P1795 Remondis Tomago RFI August 2021

**Proposed resource recovery facility, 21D School Drive, Tomago NSW  
Response to TfNSW RFI dated 23<sup>rd</sup> July 2021**

Figure 1 – Figure 2-10 from Seca Solution TIA showing survey results for July 2020 (school holidays)

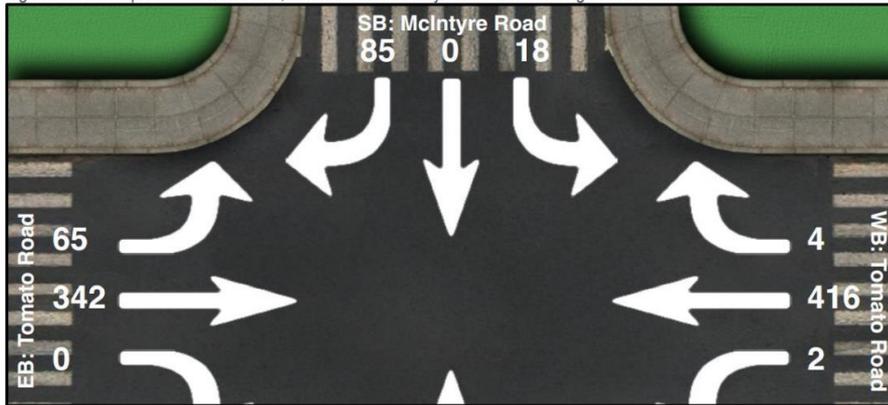
*That the traffic volumes collected are not relevant to understanding the existing traffic environment. The traffic counts for the Tomago Road and McIntyre Road intersection were undertaken on 6 July 2021, which was within the NSW school holiday period. It is considered that the surveyed traffic volumes would unlikely represent typical Tomago Road peak hour traffic volumes.*

The surveys at Tomago Road and McIntyre Road were actually collected on the 6<sup>th</sup> July 2020, not 2021. Notwithstanding this, the date in 2020 was the Monday on the first day of the school holidays in NSW. The surveys were completed at this time, as it was considered that the traffic flows at this location would not be greatly impacted by school traffic. There are no schools within this location that would influence traffic demands associated with school drop off / pick up. Covid restrictions at that time reduced the extent of holiday travel and as such it was considered at that time that the traffic demands at that time were reflective of normal traffic demands in that location.

Viewing the above survey results, the traffic flows from July 2020 are still considered valid with the traffic flows on Tomago Road being similar eastbound and in fact higher westbound in 2020, which would have a greater impact on the critical right turn out traffic movement from McIntyre Road.

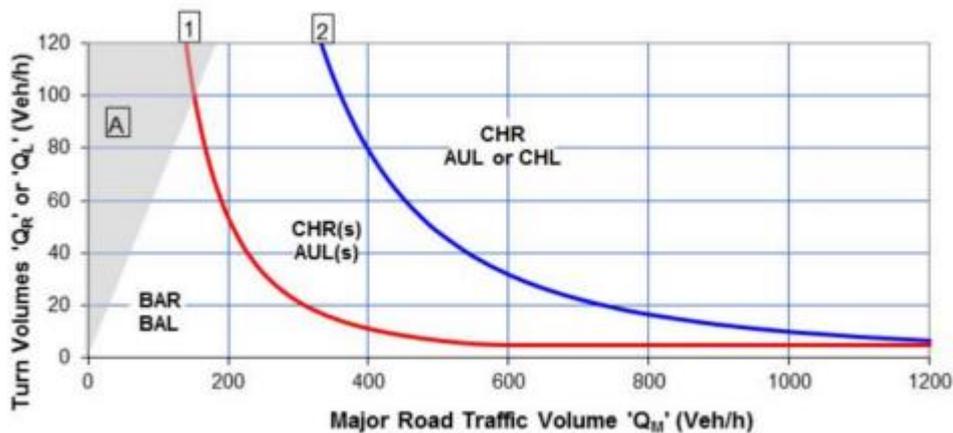
The proposal does not adequately address the capacity of the intersection to accommodate the proposed traffic. The intersection is currently configured as a Basic Right (BAR) and Auxiliary Left (AUL) type intersection. The intersection has been modelled using Sidra, with the right turn demonstrating failure (Level of Service E) within 10 years of site operation. The site is modelled as an Auxiliary Right (AUR) turn, noting that SIDRA may not be able to accurately model a BAR. Irrespective of the limitations of modelling a BAR in SIDRA, the intersection must be assessed using the warrants for turn treatments, as outlined in Austroads Guide to Traffic Management, Part 6: Intersections Interchanges and Crossings.

The Sidra modelling does show a potential level of service of E for the right turn out in the future from McIntyre Road, however the queue is relatively low and acceptable. This delay has not allowed for any reduction in the gap acceptance over the standard value of 7 seconds, however applying the 6 second as per the RTA Road Design Guide shows that this right turn would in fact operate at a level of service of B at this time.
